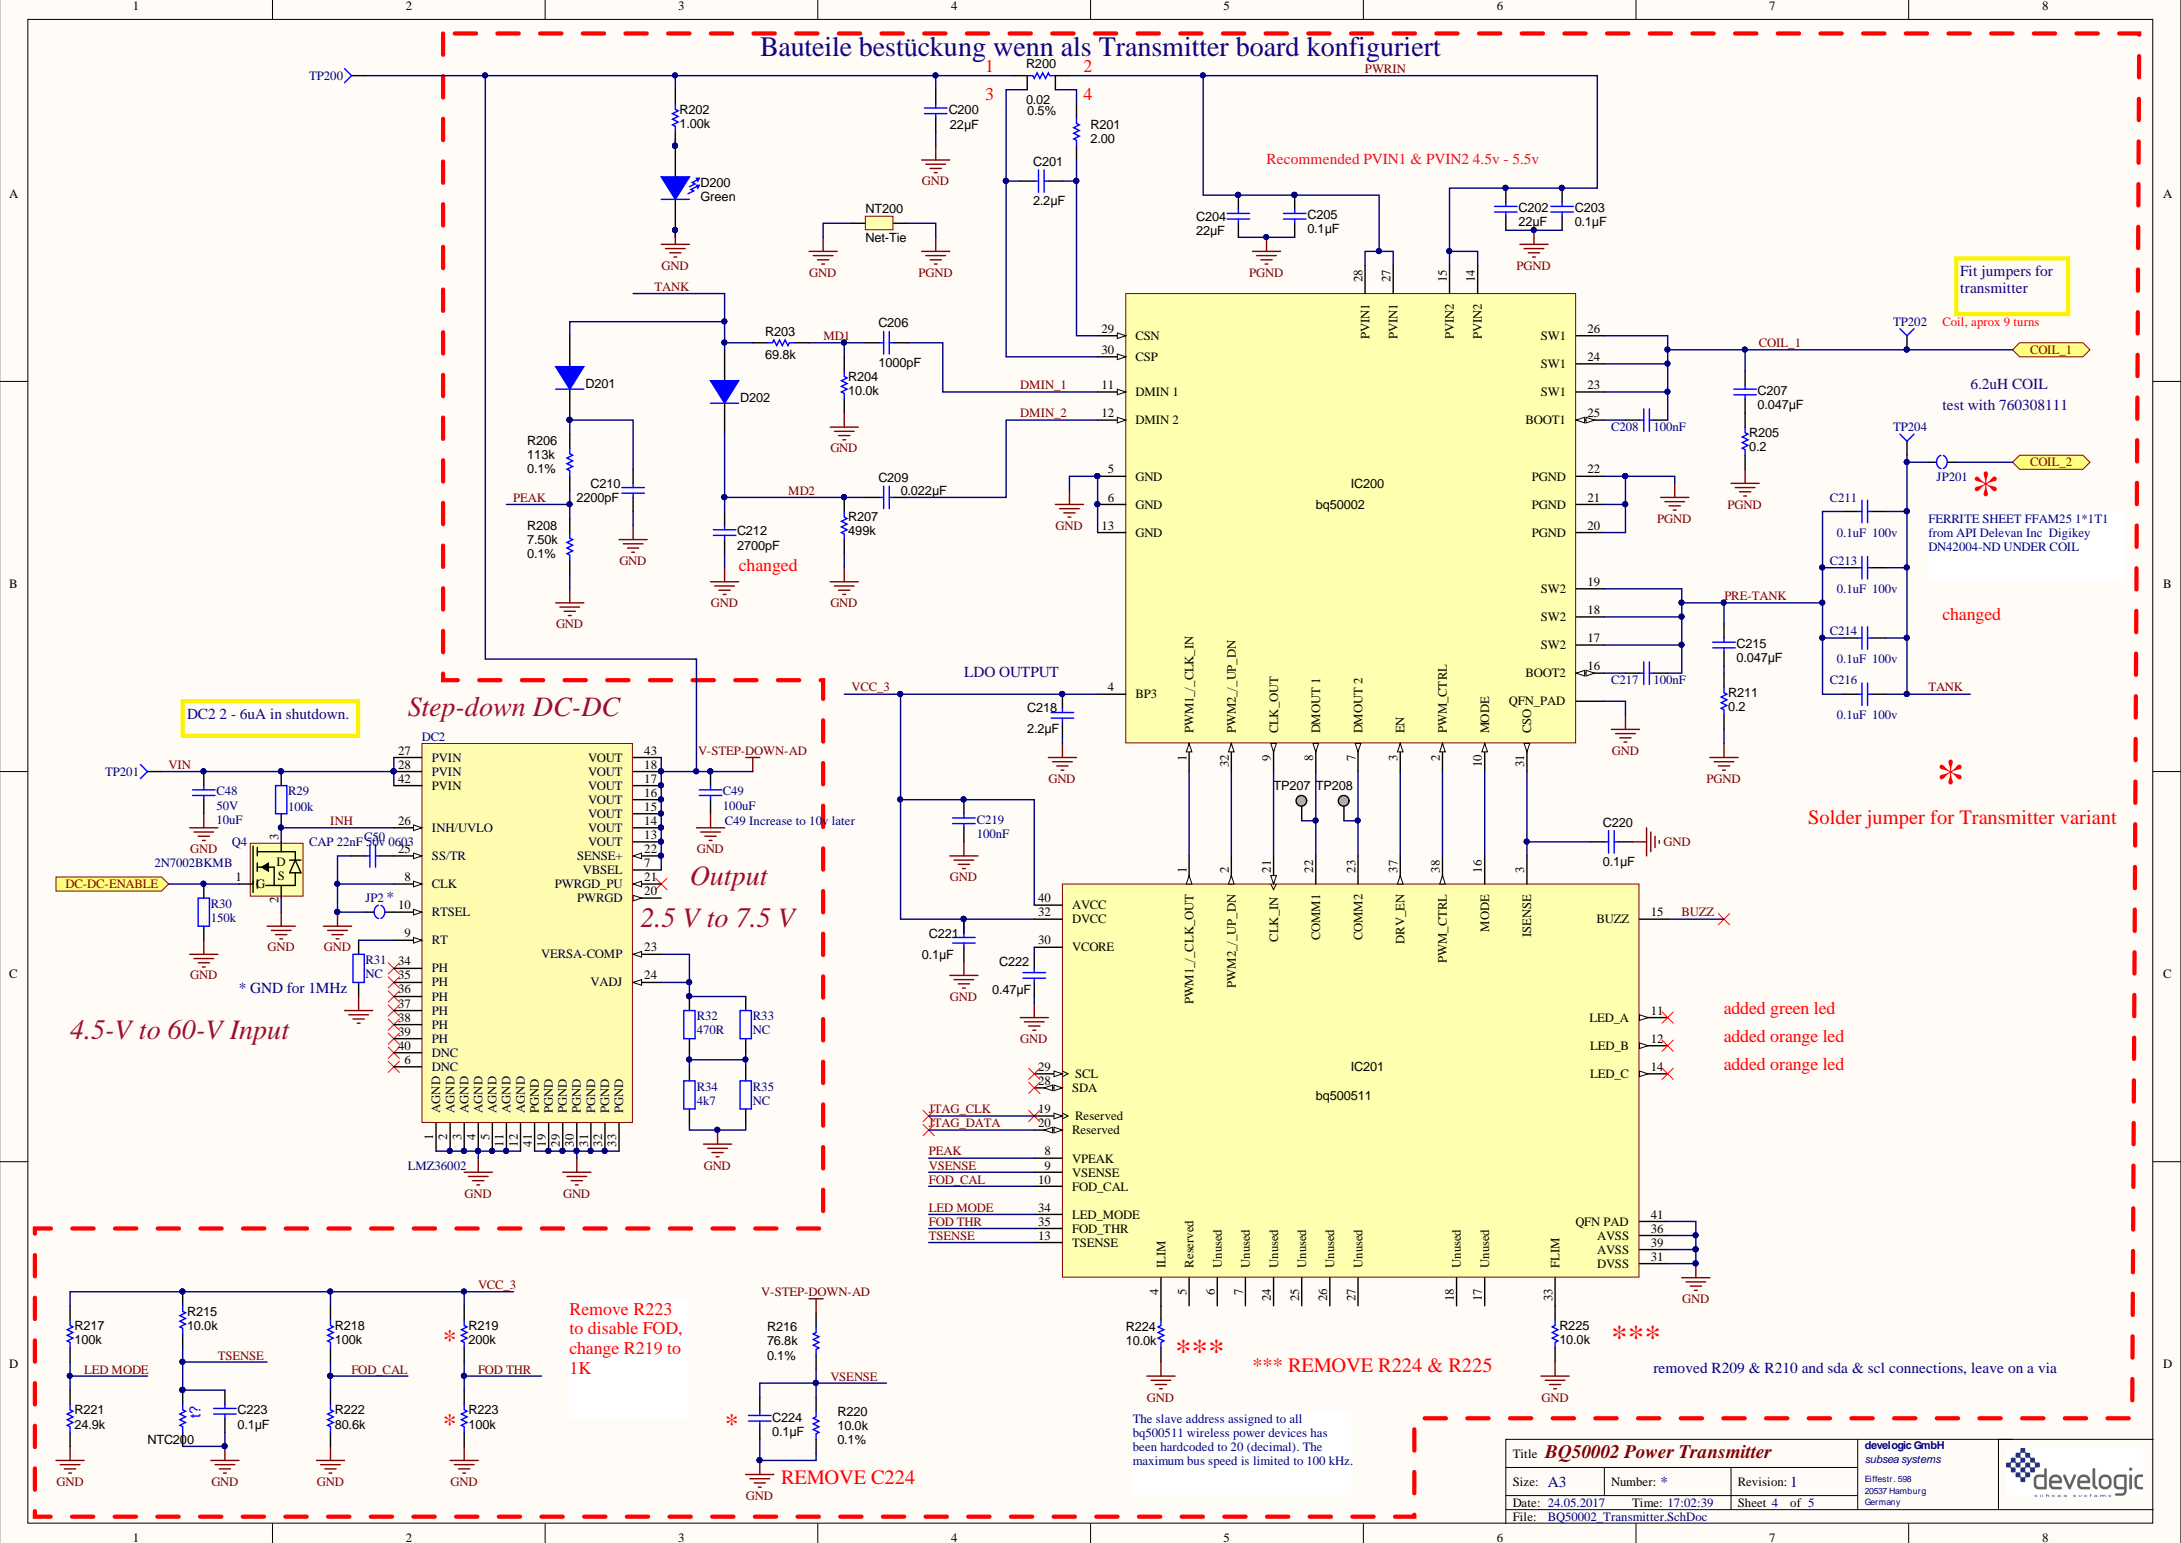
Bauteile bestückung wenn als Transmitter board konfiguriert

Fit jumpers for transmitter

Coil, approx 9 turns

6.2uH COIL test with 760308111

FERRITE SHEET FFAM25 1*1*1TI from API Delevan Inc Digkey DN42004-ND UNDER COIL

changed

changed

changed

Solder jumper for Transmitter variant

added green led added orange led added orange led

removed R209 & R210 and sda & scl connections, leave on a via
